DONCASTER BEVERLY DANBURY RECONSTRUCTION

ASSESSMENT DISTRICT - 2024

CITY PROJECT NO. 14079
CONTRACT NO. 8709

REVISION #1- 8/15/2024
REVISED THE FOLLOWING:
EC4, EC6, G11, G13-G15, PD2-PD6, P2-P6, U4-U5, W1, X4-X5, X7, X9, X12

MARK	AD#1	REVISION	DATE	BY
...	5/17/24	EKG
DESIGNED BY	MFG	DATE	5/17/2024 8:10 AM	SCALE
14079	14079	1" = 40'		U-3

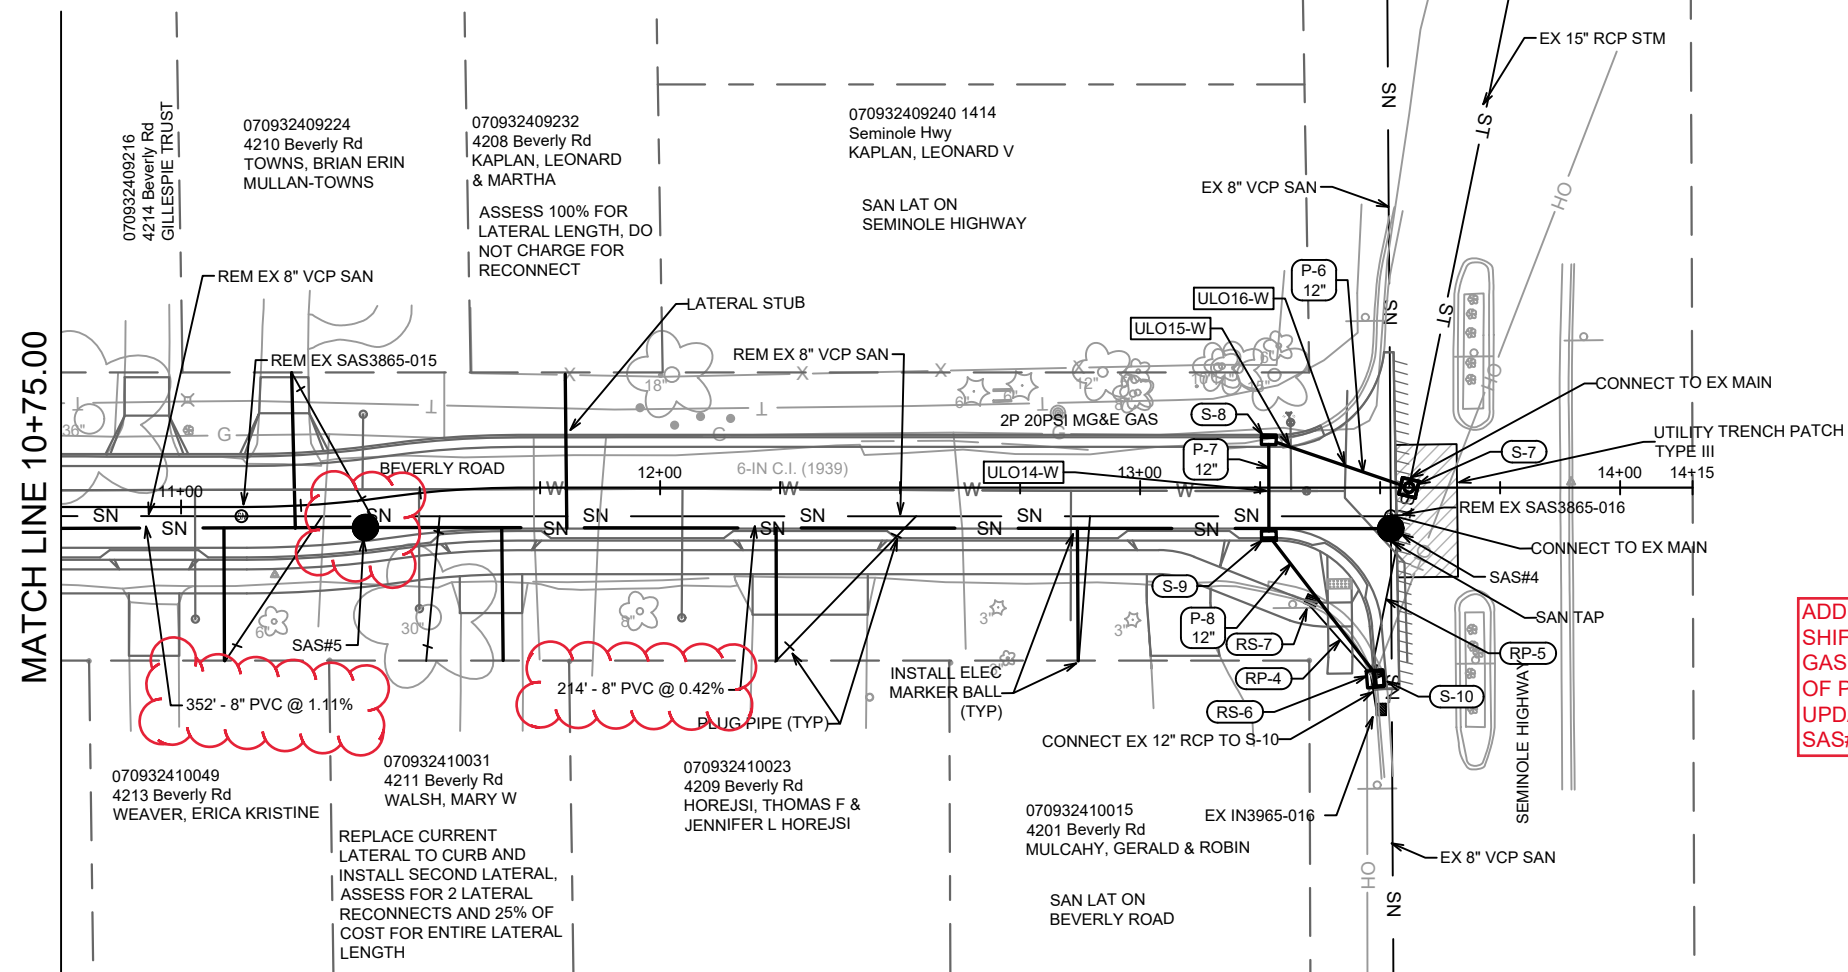
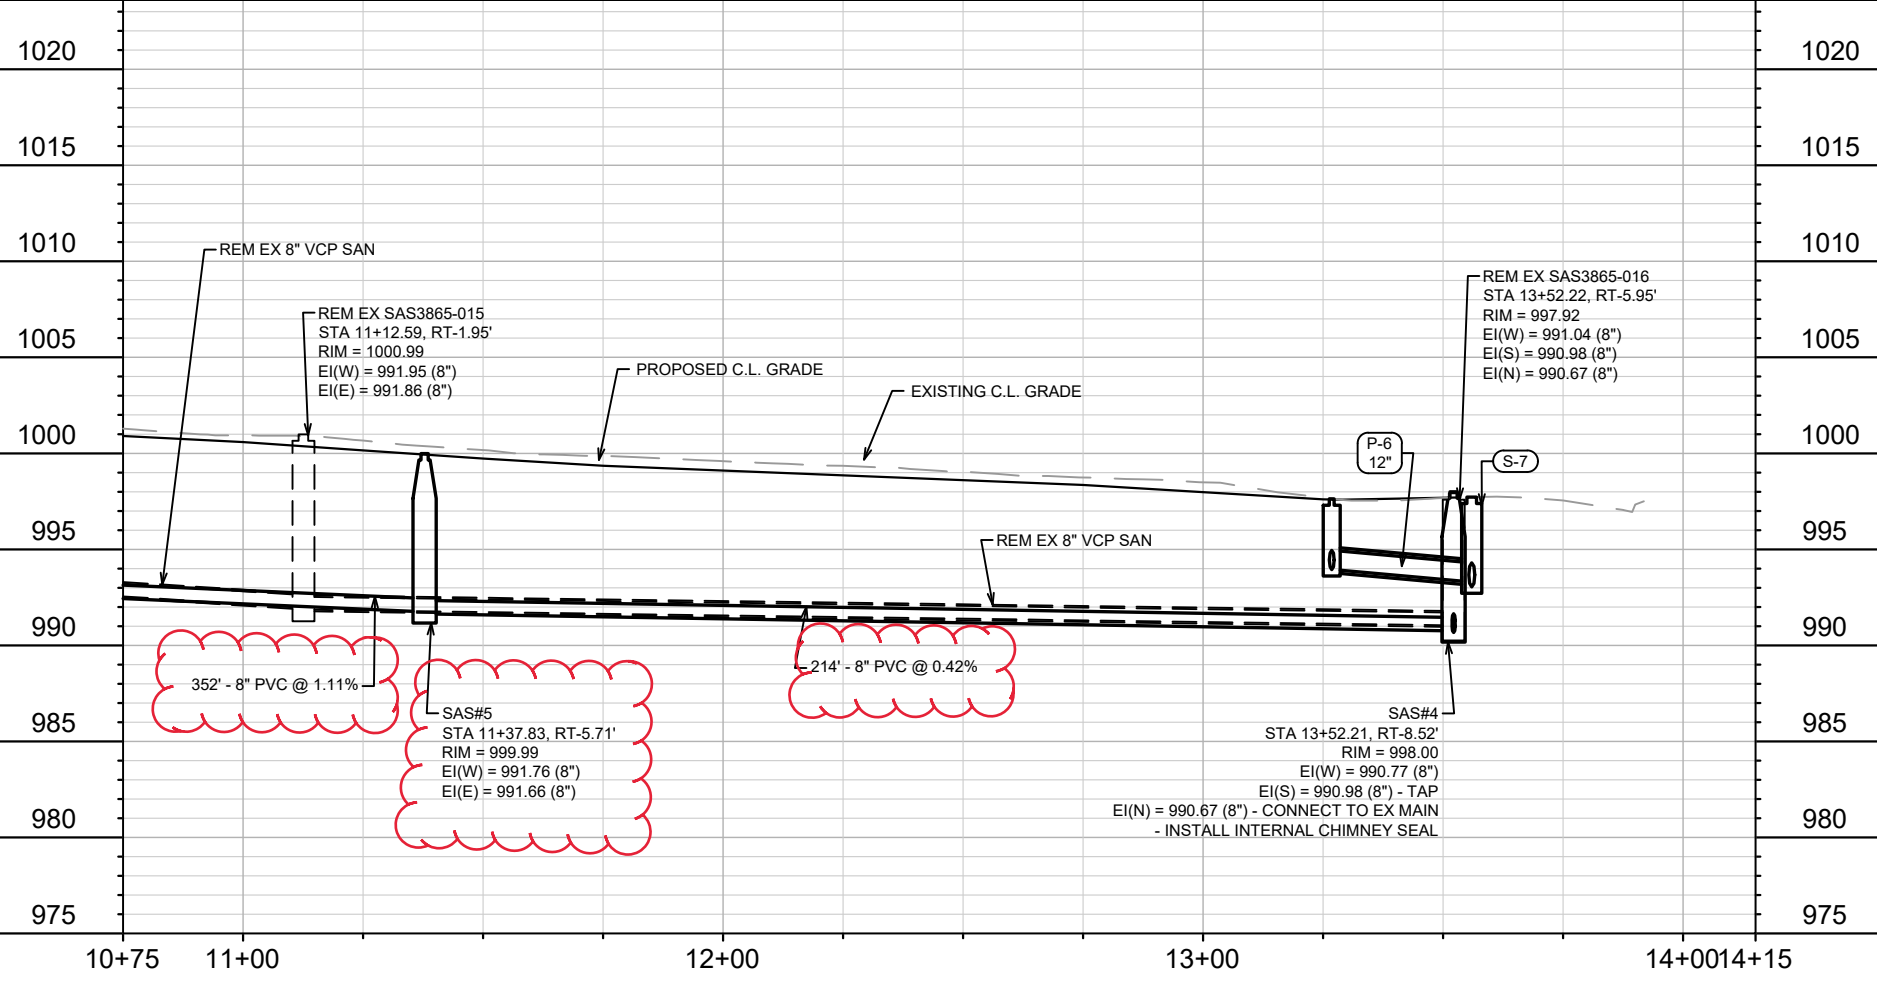
ADDENDUM NOTE:
 SHIFTED SAS#5 EAST TO AVOID
 GAS SERVICE. UPDATED LENGTH
 OF PIPE FROM SAS#5 TO SAS#6.
 UPDATED LENGTH OF PIPE FROM
 SAS#4 TO SAS#5.

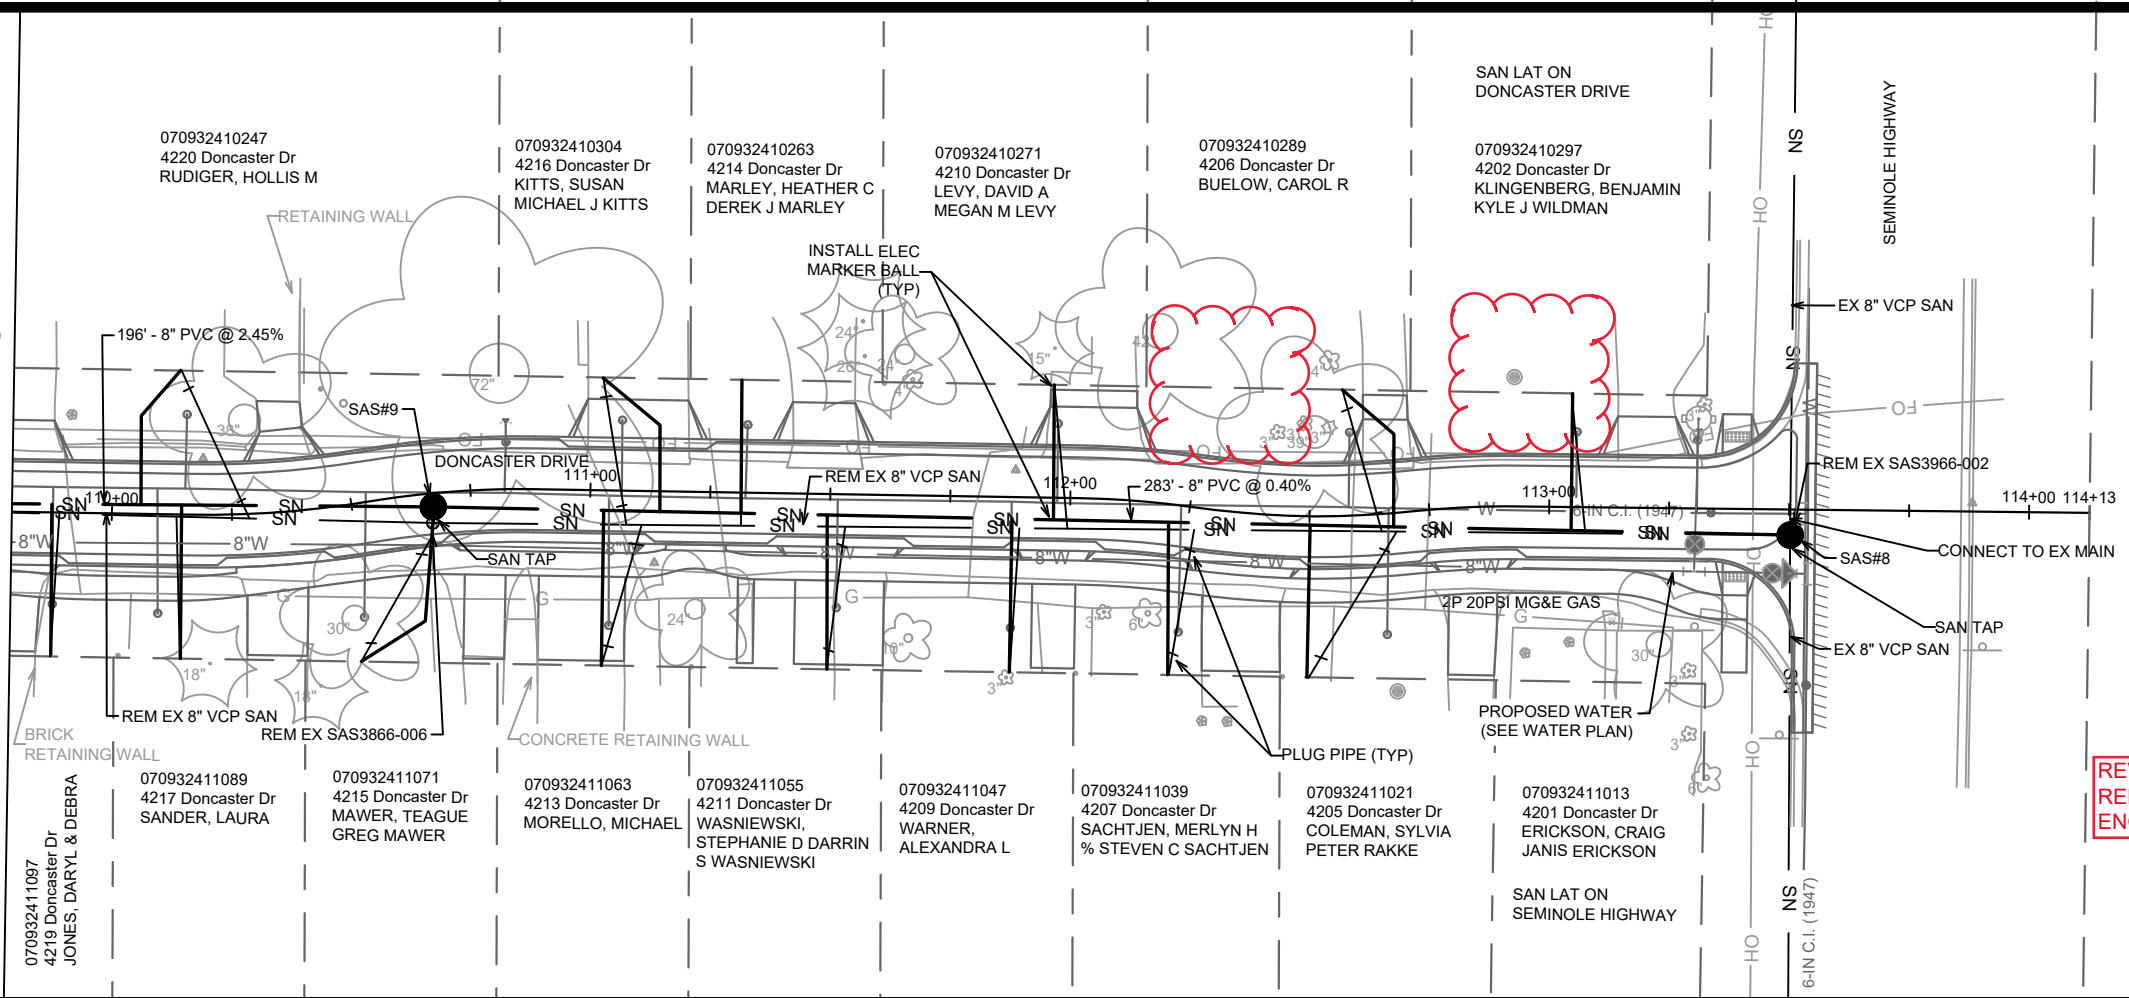
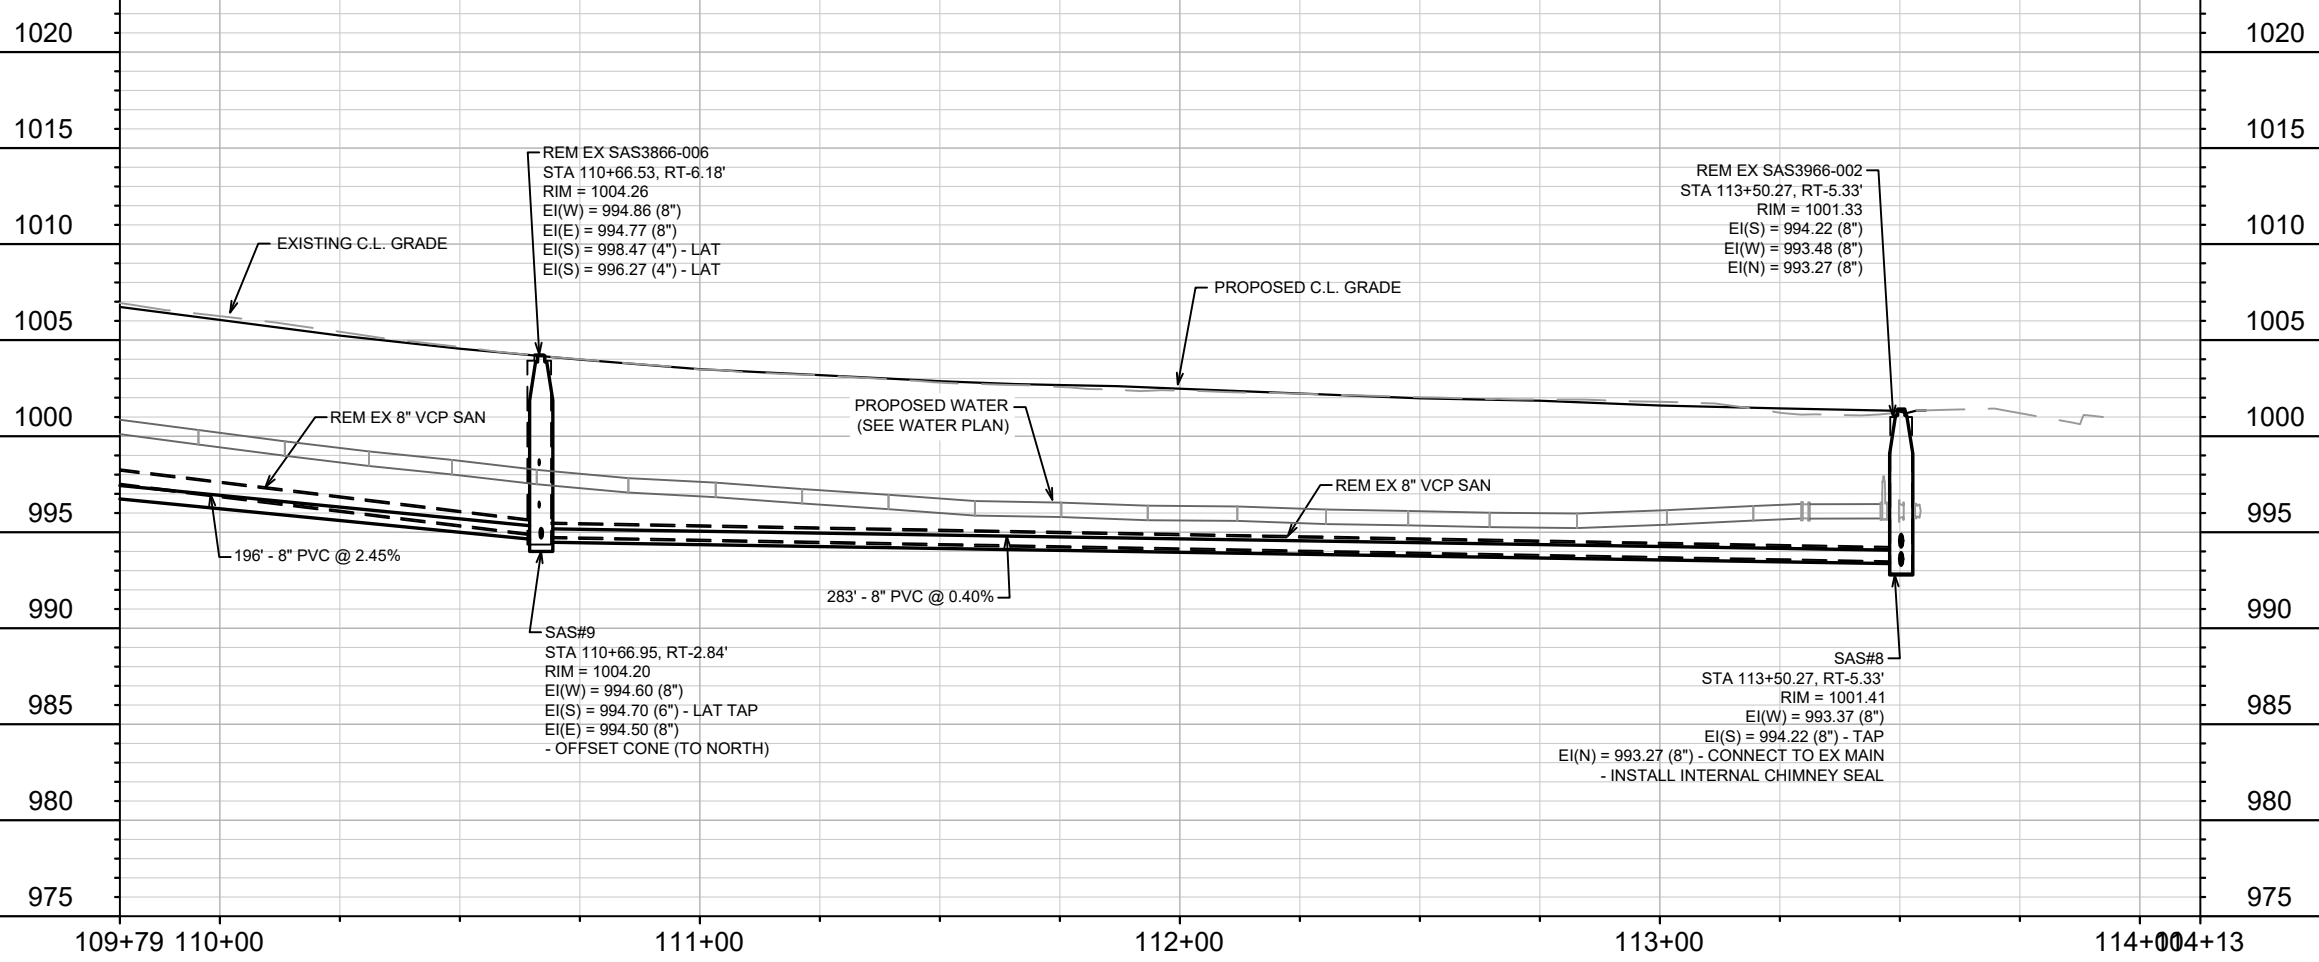
REVISION 1 NOTE:
REMOVED RAIN GARDEN ULOs PER
ENGINEERING INSPECTION.

DATE	BY
REVISION	
MARK	
Designed By: MFG	Date: 8/15/2024 1:56 PM
14079	X-9

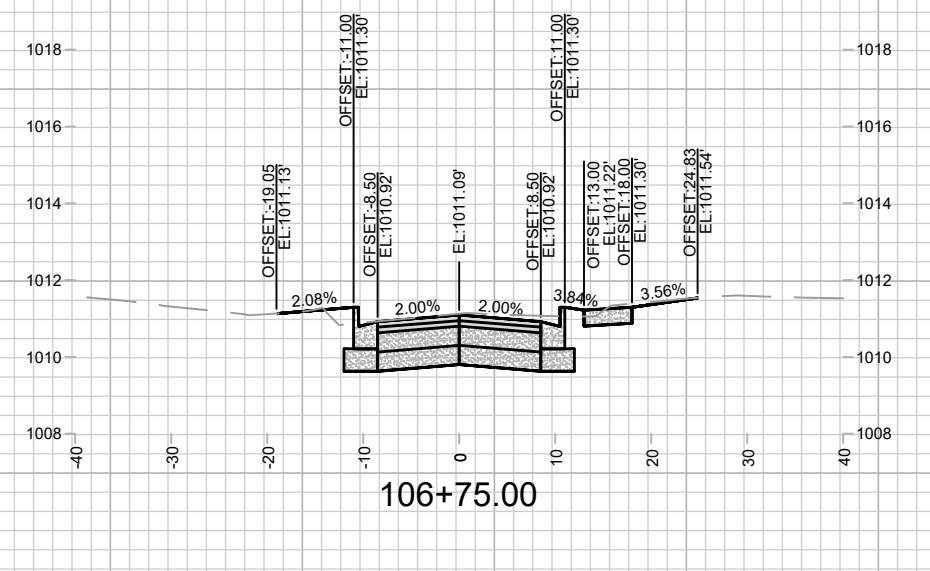
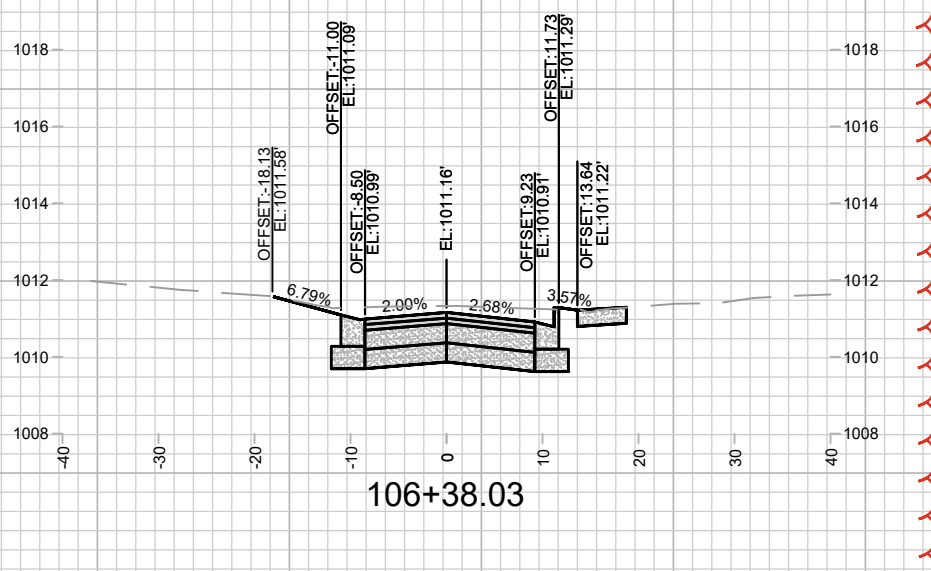
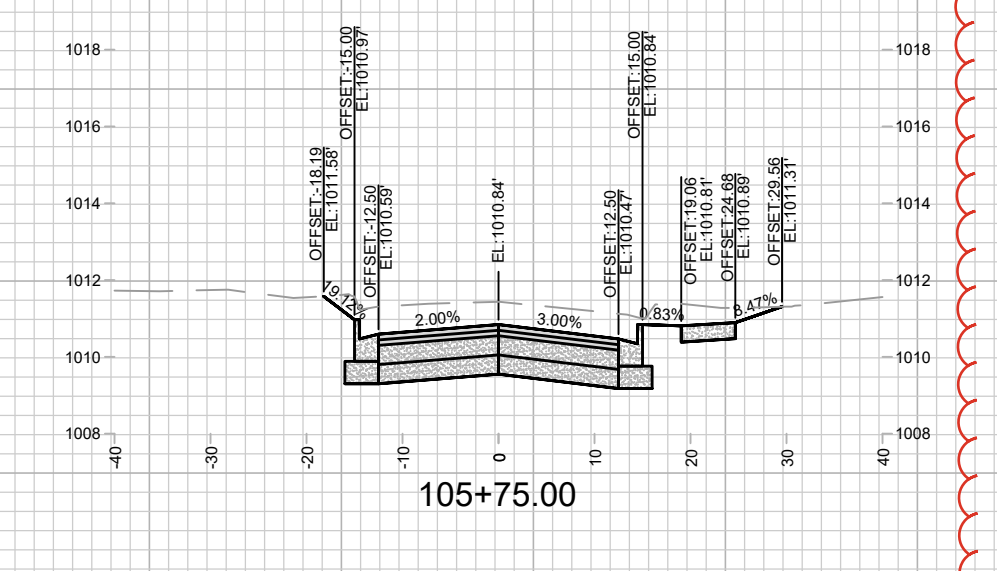
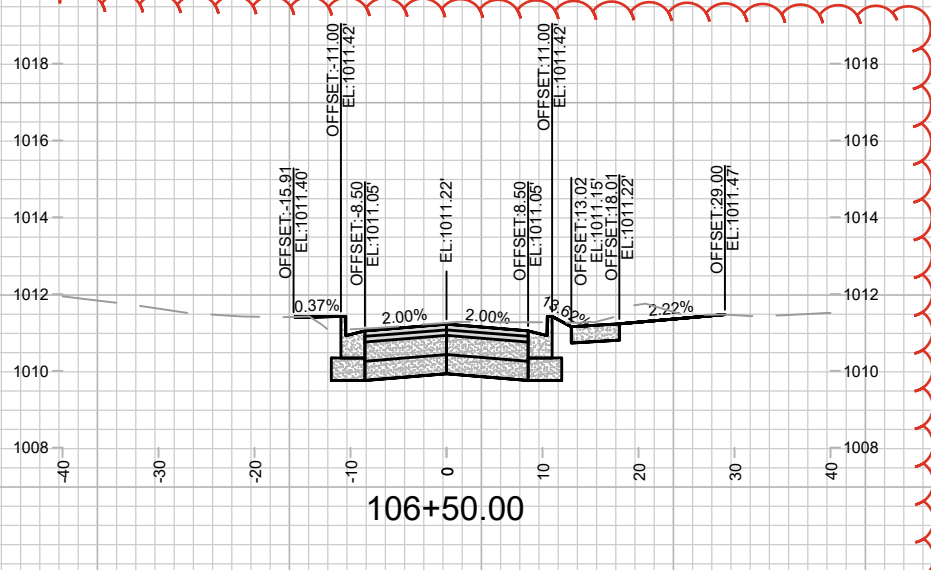
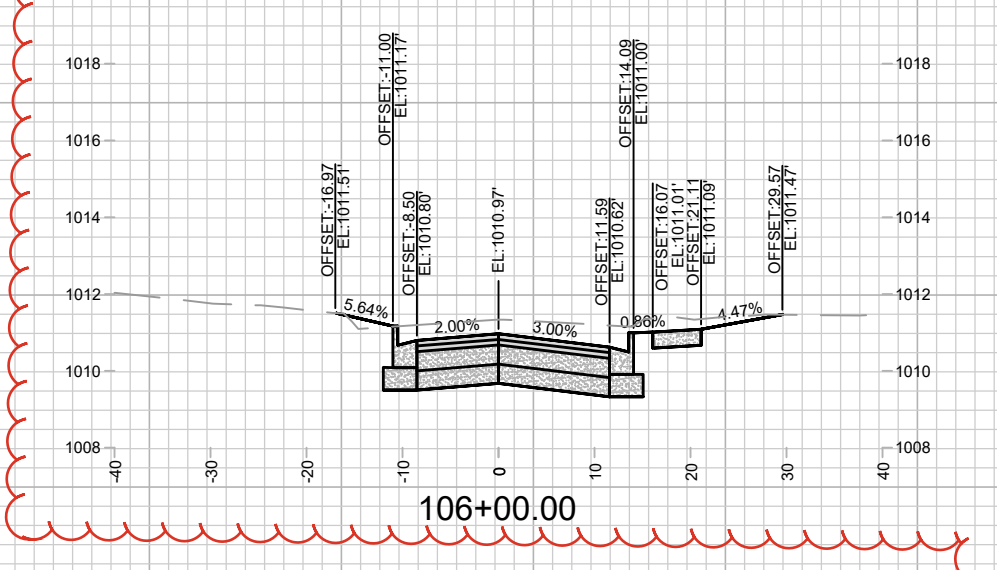
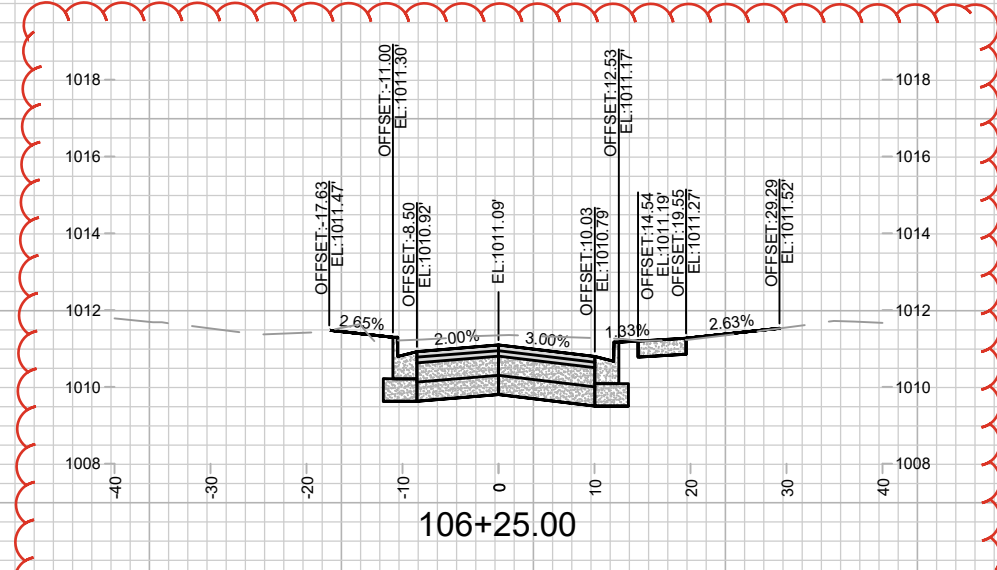
REVISION 1:
UPDATED TO MATCH
LONGER TAPER
